Mr. Alex Forbes
Manager Planning & Heritage
Planning & Heritage Department
70 Kent Street
Charlottetown, PE
C1A 1M9
Planning@charlottetown.ca

July 2, 2021

I, Andrea Battison, as an aggrieved person respectfully request that the City of Charlottetown reconsider the approval of the site specific exemption amendment for 199 Grafton Street (207-BYL-21) which passed second reading of Council on June 14, 2021. This request is made under provisions 3.15.3.a and 3.15.3.c of Section 3.15 Reconsideration, of the Charlottetown Zoning and Development Bylaw (hereafter referred to as 'the *Bylaw*').

1:15 PM

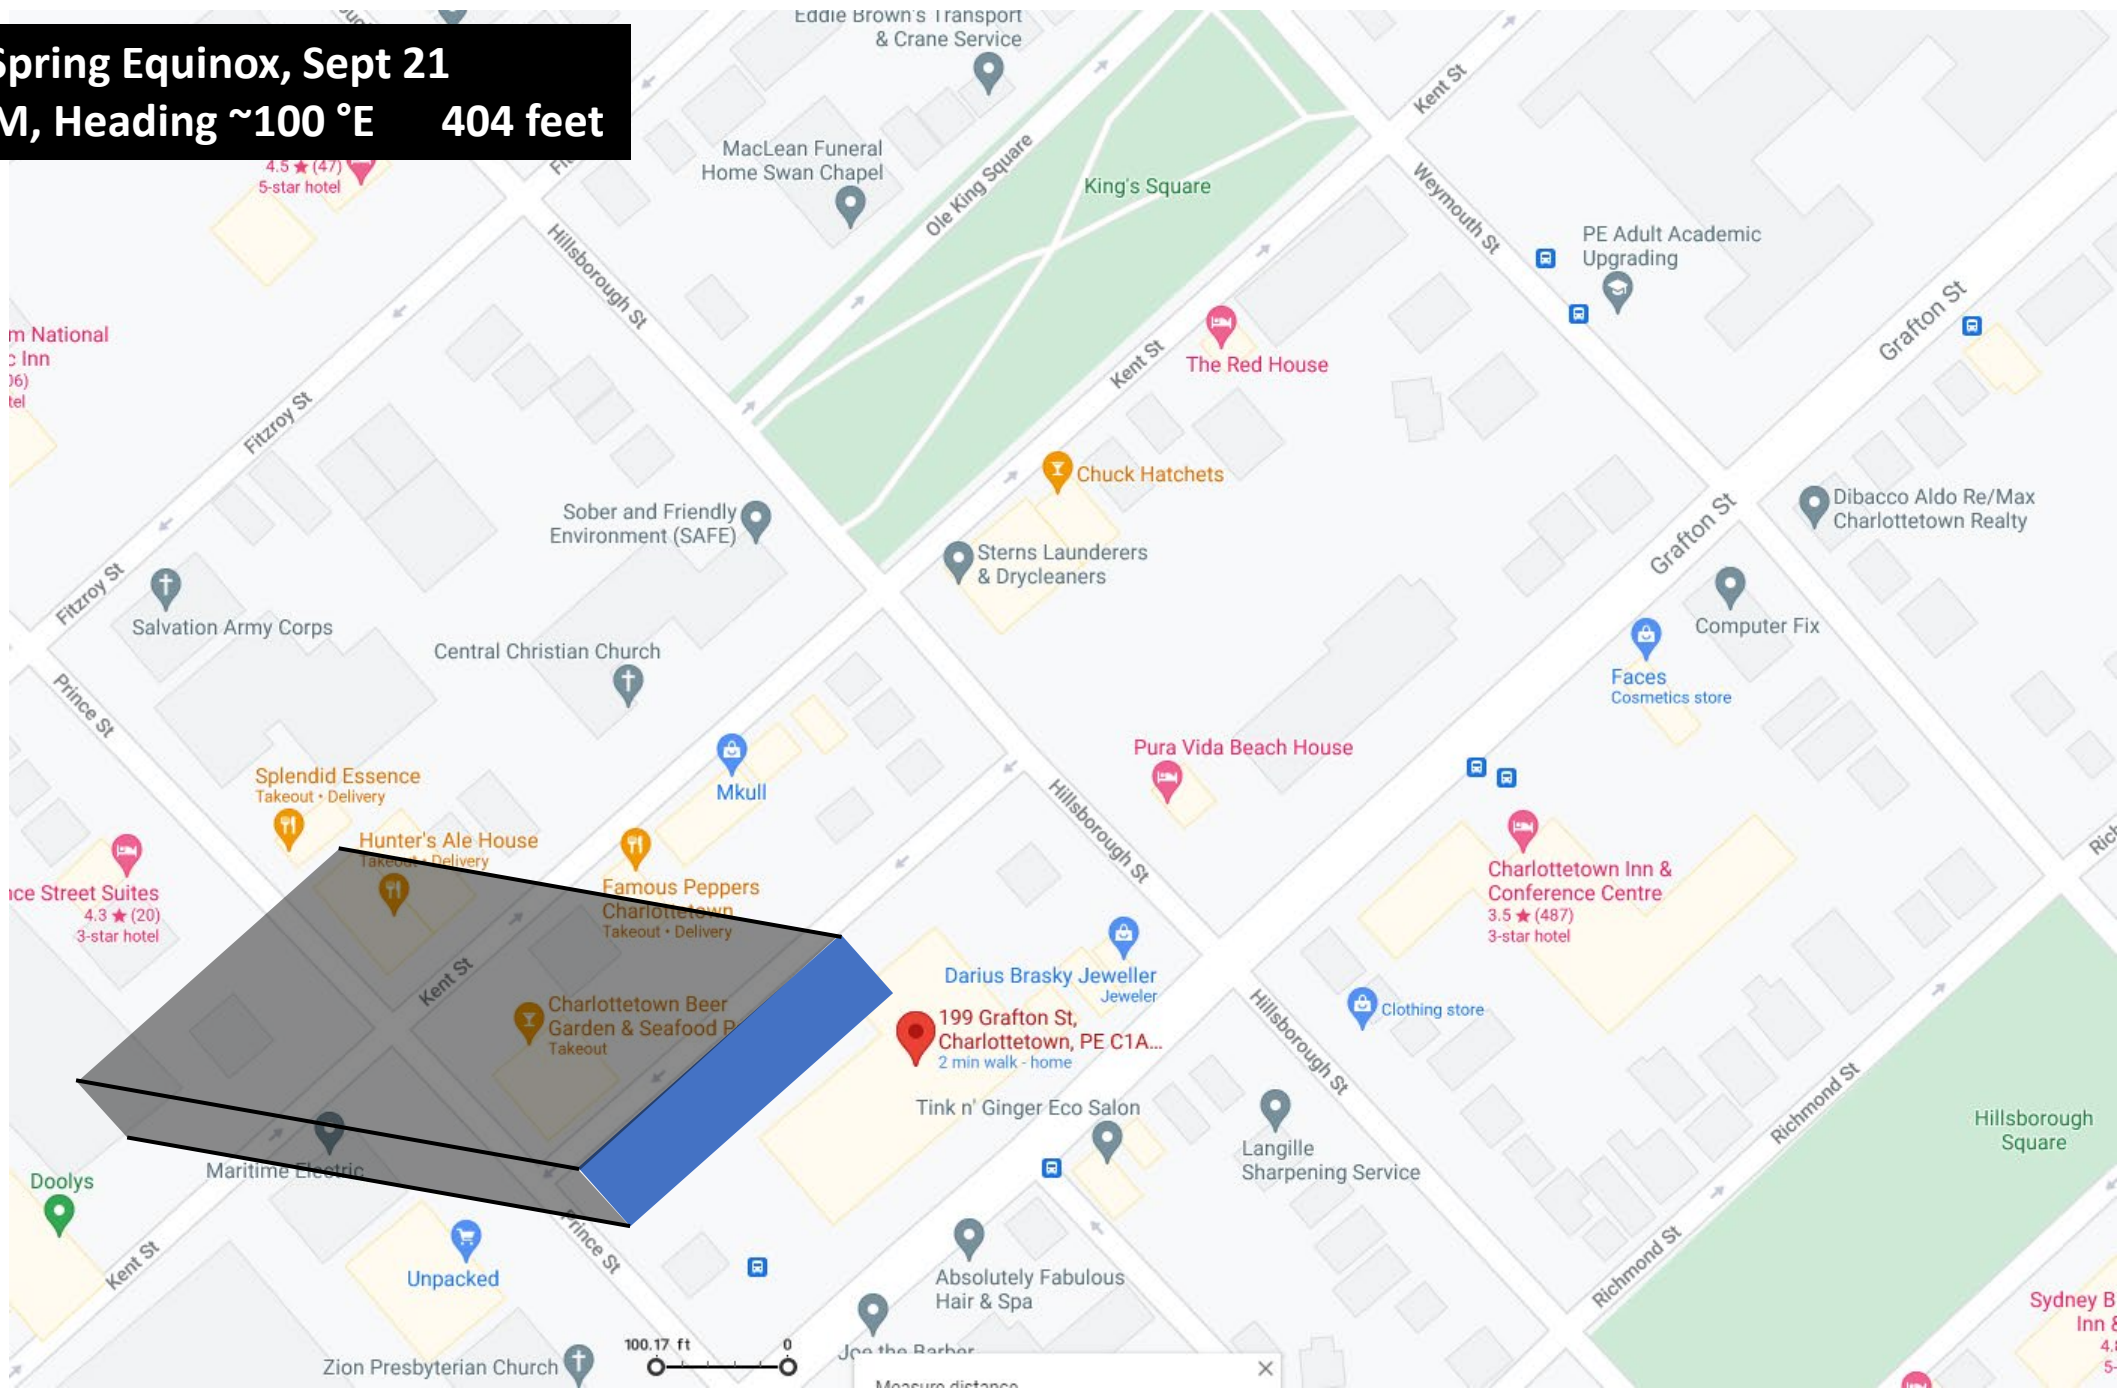
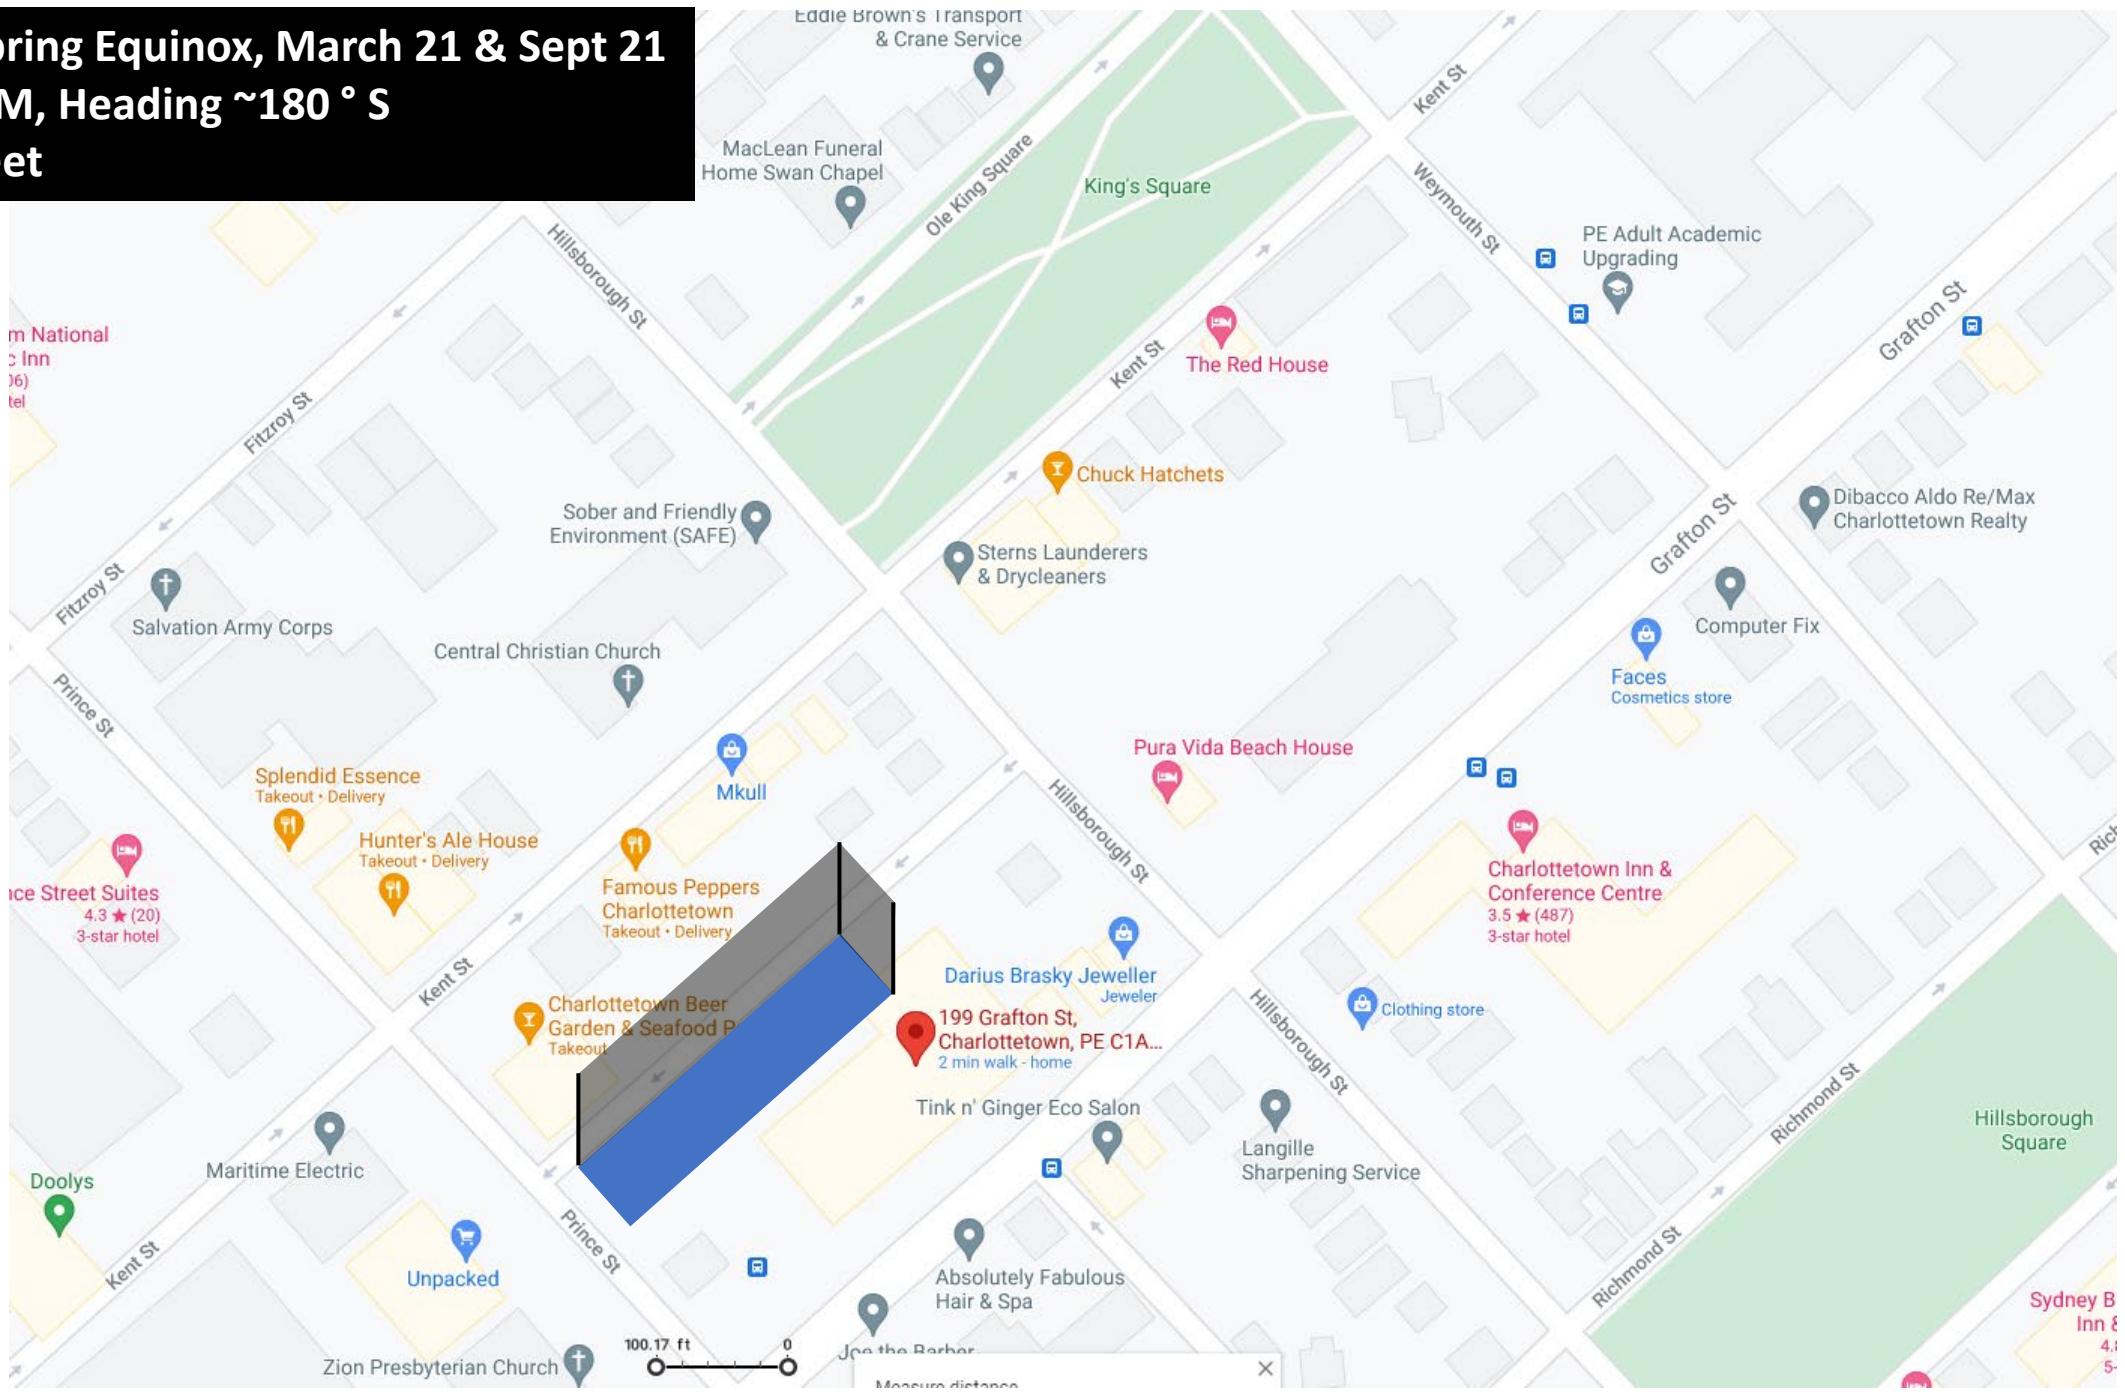
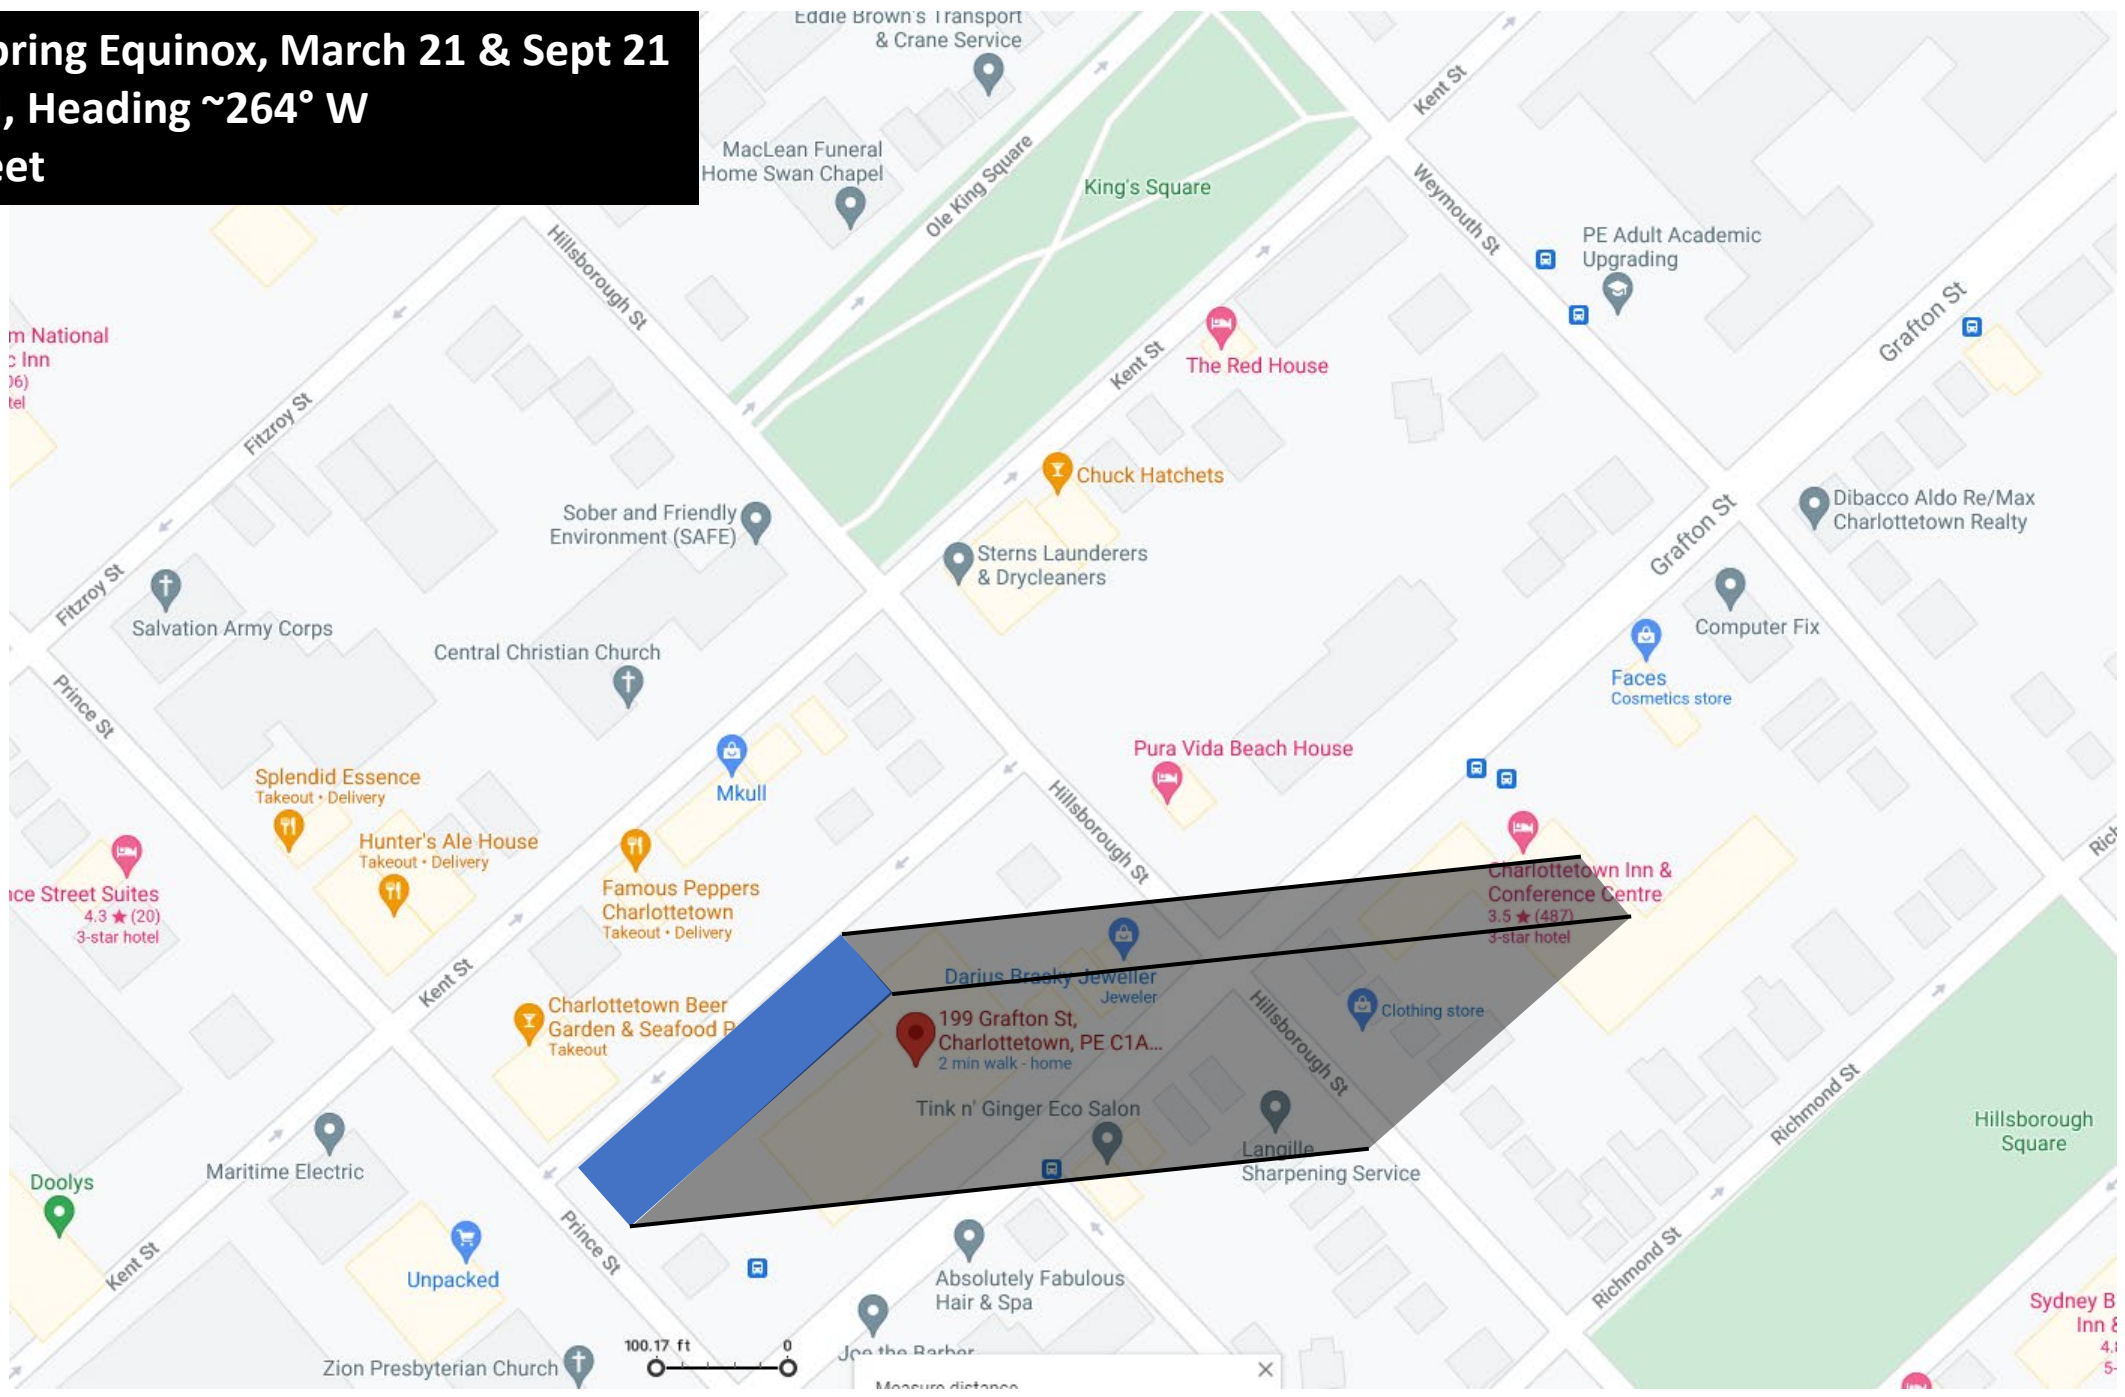
The shadow diagrams in Appendix A, are not as accurate nor as complete as professionally prepared ones for a shadow impact study which would comprise cumulative shadows and show a change in shadows. They do however, at a minimum, indicate that shadows could be a relevant feature of this proposal and that a shadow impact study would be valuable in assessing to what degree the height and length of the building will affect neighbouring residents.

Given the potential for negative impact on health due to decreased access to sunlight that the current residents on Kent Street are accustomed to and limitation of the use of solar panels, it is argued that a shadow impact study is required.

Travelling west on Clarke St., views of approaching pedestrians on Prince St. are blocked, creating a public safety hazard.

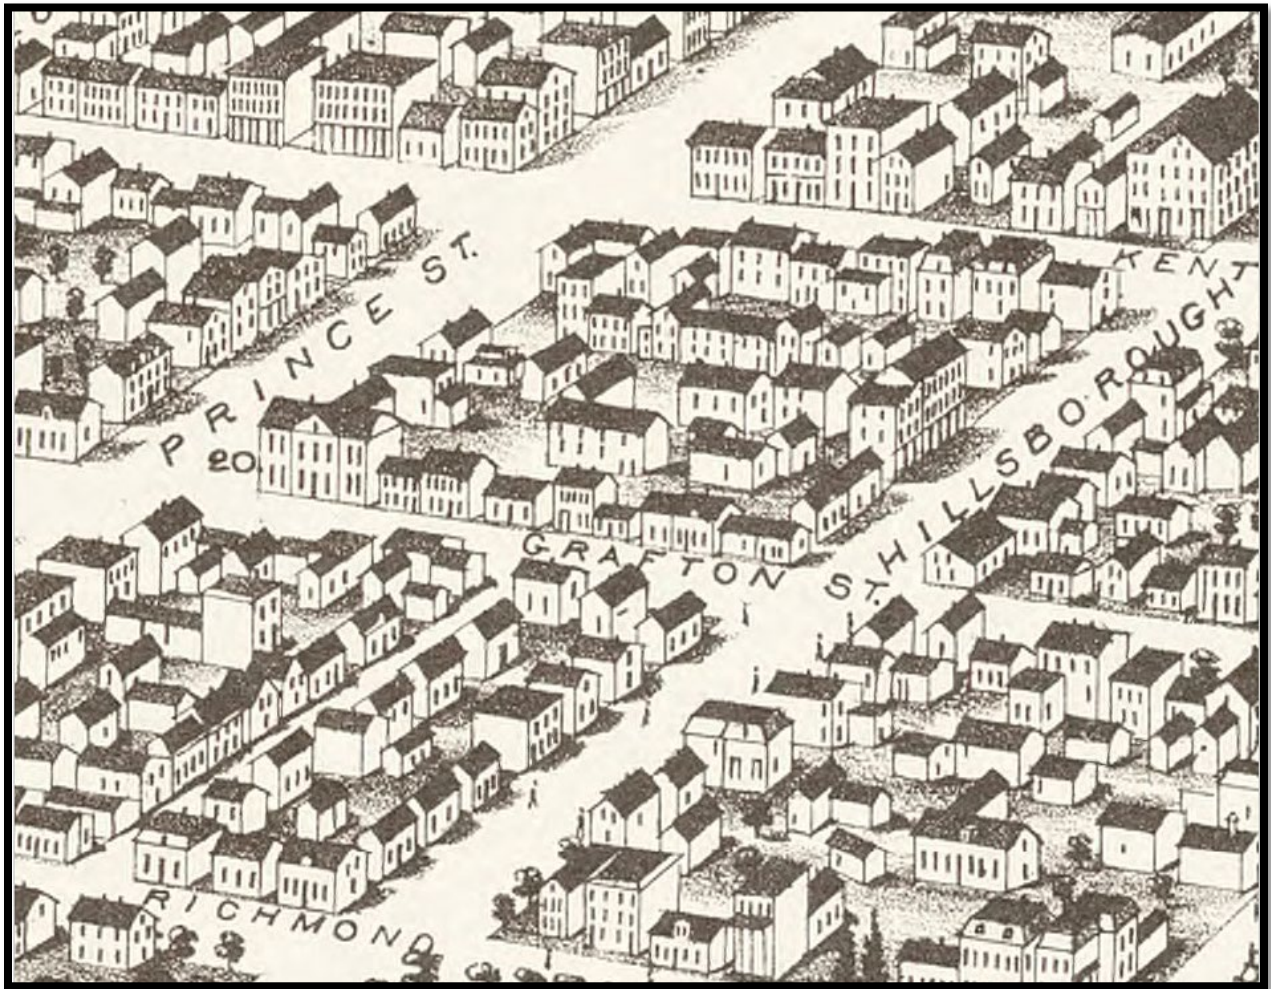
It is argued that by not requiring a sight triangle as per section 4.10 of the Bylaw for a street with known regular large vehicle traffic and restricting the ability to provide a sidewalk on Clarke Street if a setback variance is granted, the City is being derelict in its duty to ensure public safety and therefore, the site specific exemption amendment request should be rejected under section 3.3.8.e of the Bylaw.
